ADDENDUM

Project Name: Recreation Authority of Roseville and Eastpointe **Addendum No: Three (3)**
Recreation Authority Center
Addition and Renovation

Project Number: 13-162 Issue Date: June 17, 2014

Project Location: Roseville, Michigan

Item A1 Drawing A0-03; OPENING SCHEDULE DOOR / FRAME TYPES (reissued with this addendum)

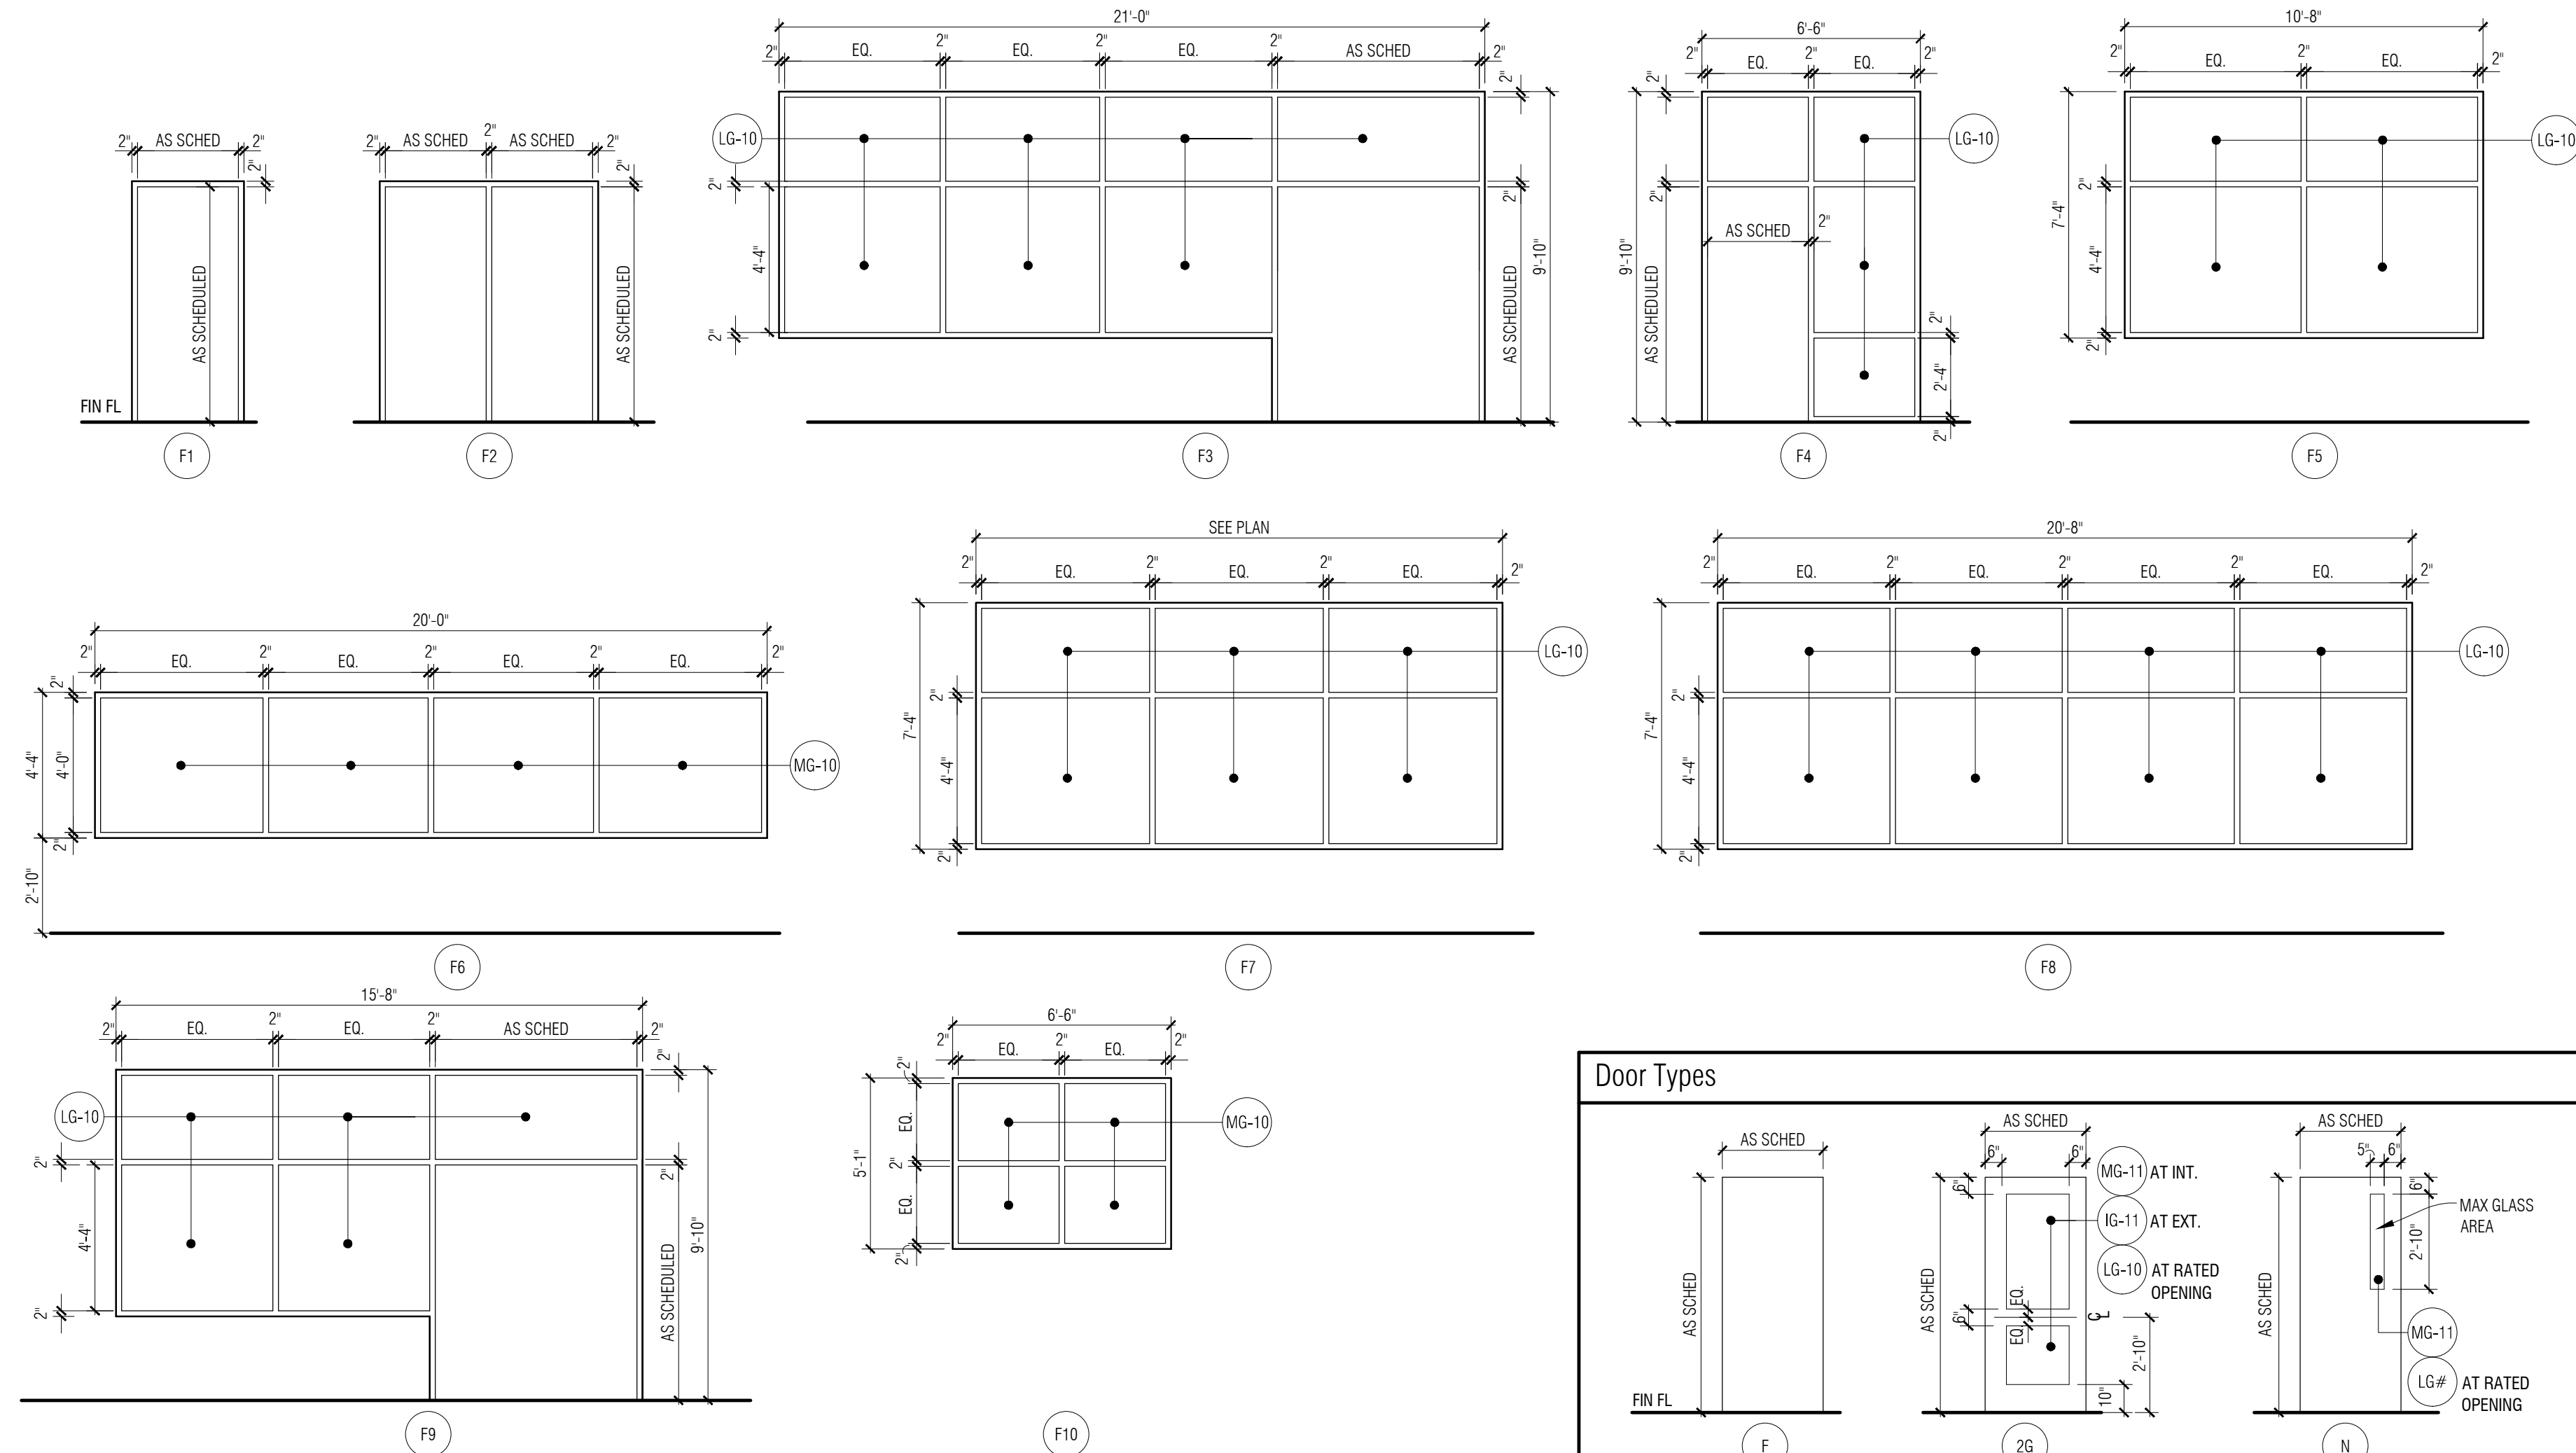
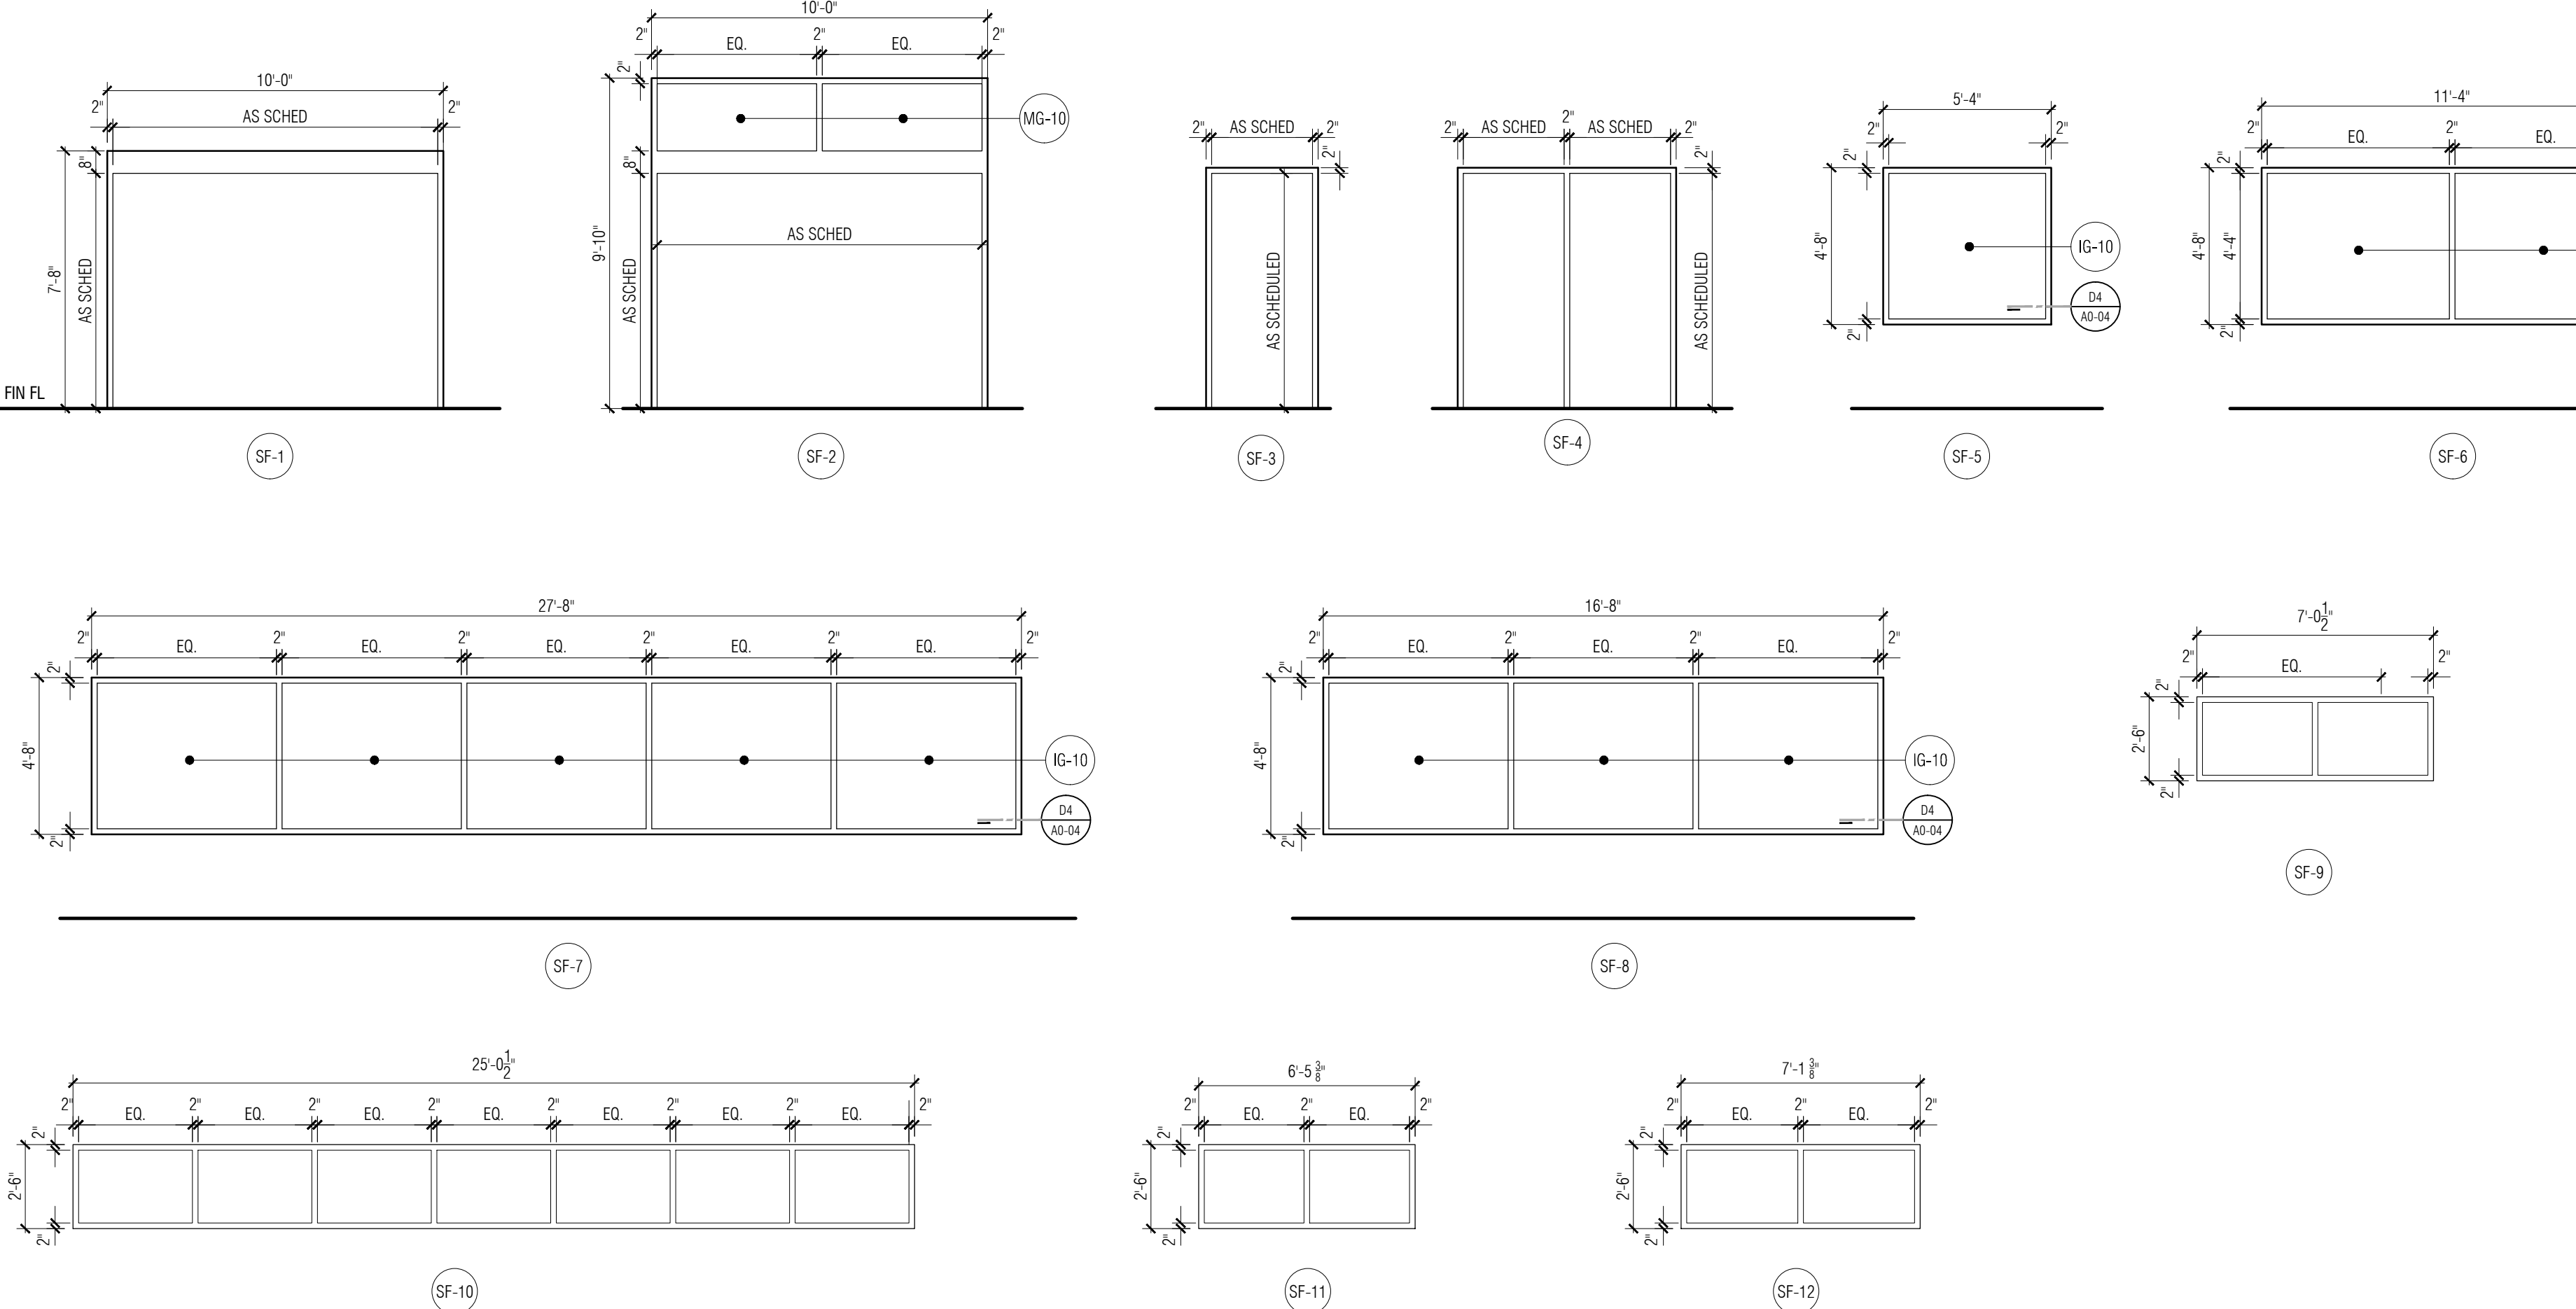
A. Refer to drawing A0-03 OPENING SCHED, DOOR AND FRAME TYPES reissued to include additional doors indicated on floor plan drawing A3-01, and A3-02.

B. Refer to reissued drawing A0-03 for hardware sets index information.

C. Refer to opening schedule key not 8 for allowance to be included per leaf for doors indicated. Allowance cost to be included in base bid.
